Subject: FW: New Urban West/Meadows at Bailey Canyon Monastery Development: 501 Crestvale Drive, Sierra Madre, CA 91024: Unresolved Critical Issues and Request to Stay a Decision

Subject: FW: For Tonights Planning Commission meeting
Attachments: PC re conversations with County.docx; Answer to Commisioner Hutt's question.docx; Concerns of Flooding.docx; Re Storm Drain and Carter.docx; PC SERIOUS CONCERNS OF FLOODING.docx; New Drainage Plan in Specific Plan.docx

To the Planning Commission for their August 18 Meeting

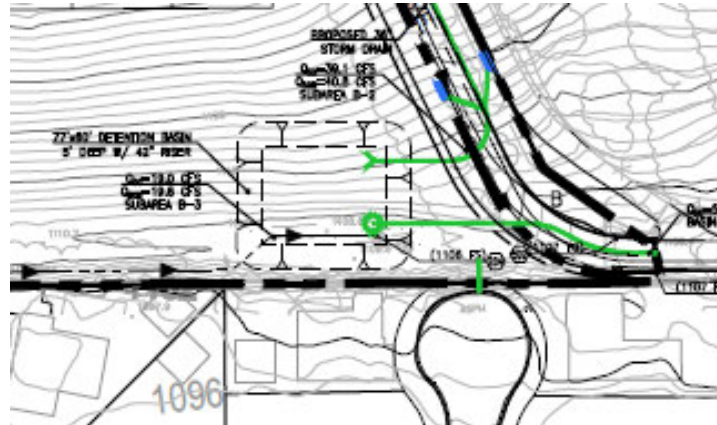
The Hydrology plan before the Planning Commission now bears no semblance to what was included in the DEIR and FEIR. The Berm, the Sunken Park and sending all Sunnyside water to the detention basin are entirely new elements of the project and its critical drainage plan. They were never presented or studied in the DEIR or by the City or County and are contrary to the Hydrology design and maps in the DEIR and FEIR.

The Developer's consultant has presented figures to assure the committee that their NEW plan is adequate for the safety and protection of the City. But it was the SAME consultant that presented the Hydrology Plan in the EIR without the berm they now say is essential for drainage. Their current (revised) plan acknowledges that it is subject to presenting an LID (Low Impact Development) plan which must be reviewed and accepted by the City Engineer. They have not shown that the City Engineer has seen, reviewed and accepted their present plan to send all excess storm waters, from the entire development, that are not held in the ground or the "retention basin", down Crestvale (or any city Streets at a lower elevation than the park.)

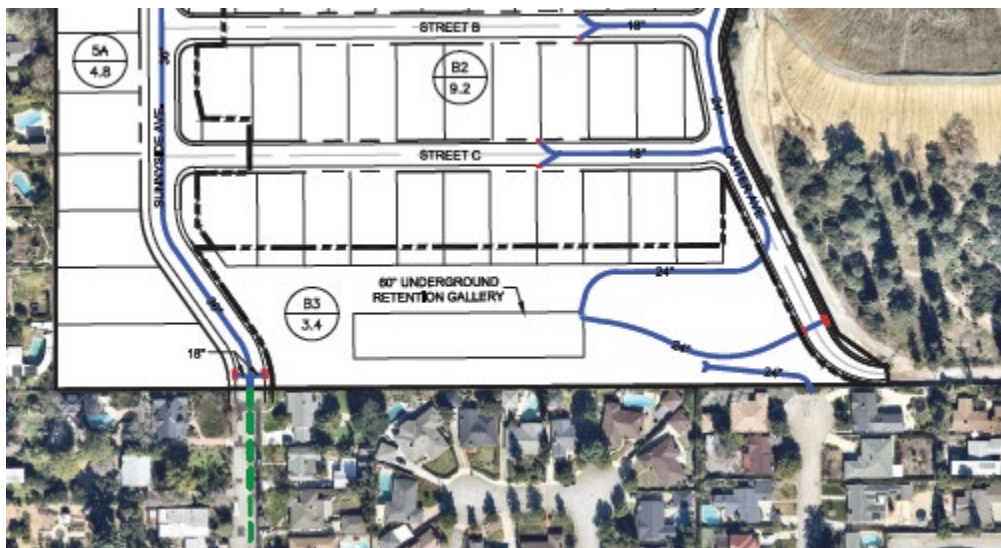
basin such as cleanout activities and trucking.

6.2. Increases in traffic affecting operation efficiency during basin cleanout.

(NOT ONE of their concerns were ever even mentioned let alone mitigated in the DEIR or the FEIR, nor were they disclosed as a permitting agency, as they asked“

3. The plan shown in the latest version of the Specific Plan raises more questions. It is entitled "Required 50 year retention volume for Crestvale Drainage Area = 128,880"

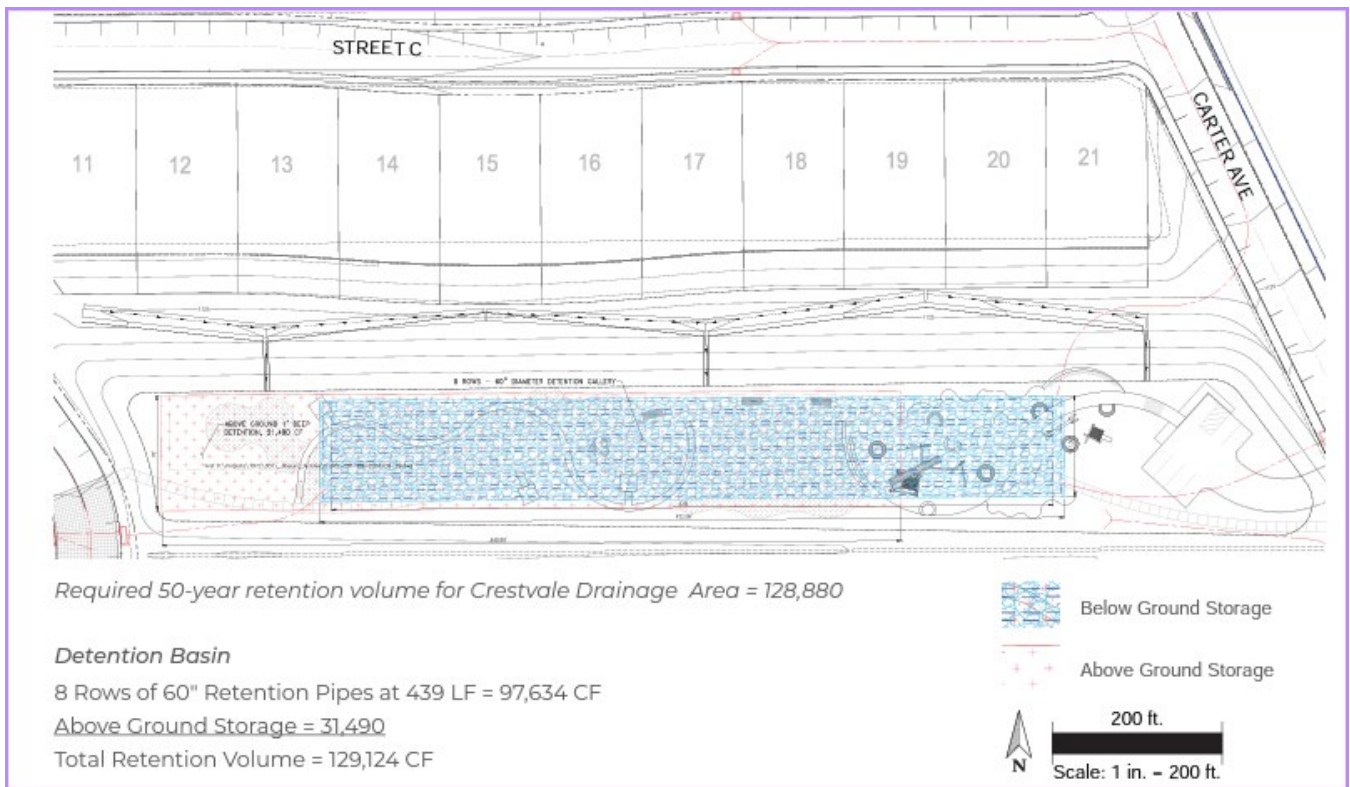
On the west side of the plan is the beginning of an "above ground storage" 1' deep detention basin which continues for most of the length of the "Below Ground Storage" Both the above and below ground drainage areas cover almost all of the walking paths and amenities of the proposed park and appear to extend north to the retention walls to the first tier of houses.

The "Above ground storage" is labeled one foot deep. You have said that the park will be sunken - how far below present grade are the paths and amenities of the park? Will this above ground storage be higher than that grade? How much higher will the berm be?

What is the remaining usable length and width of the park? (Land not sloped to the north and not covered by the berm)?

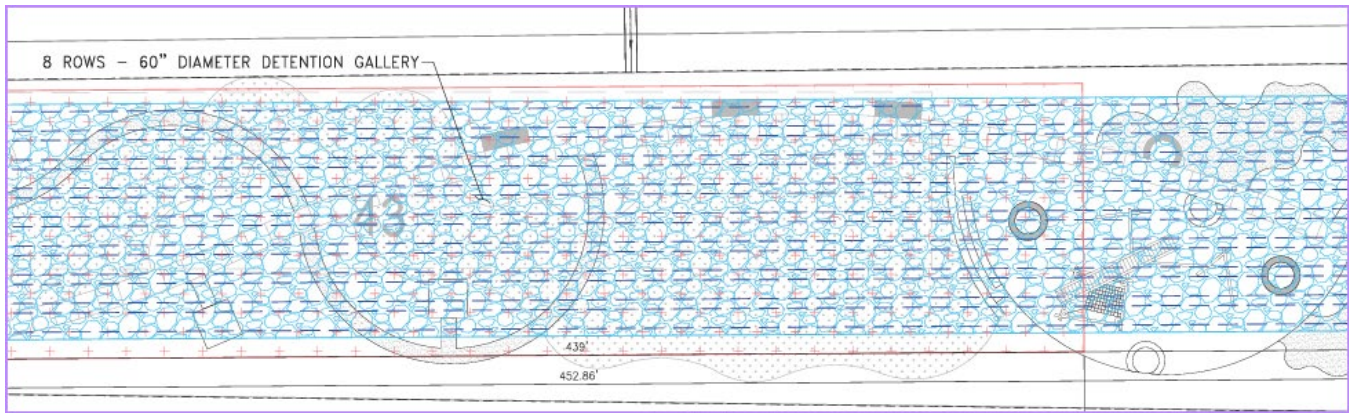
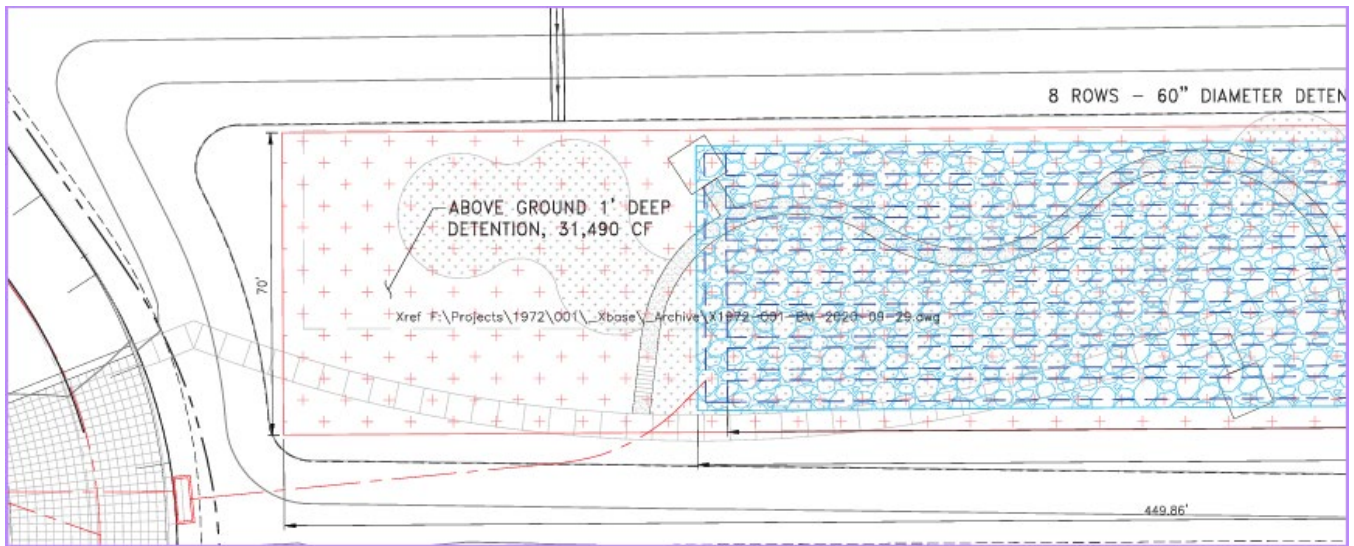
It appears that the planned walkway from Sunnyside will go through the above ground storage area
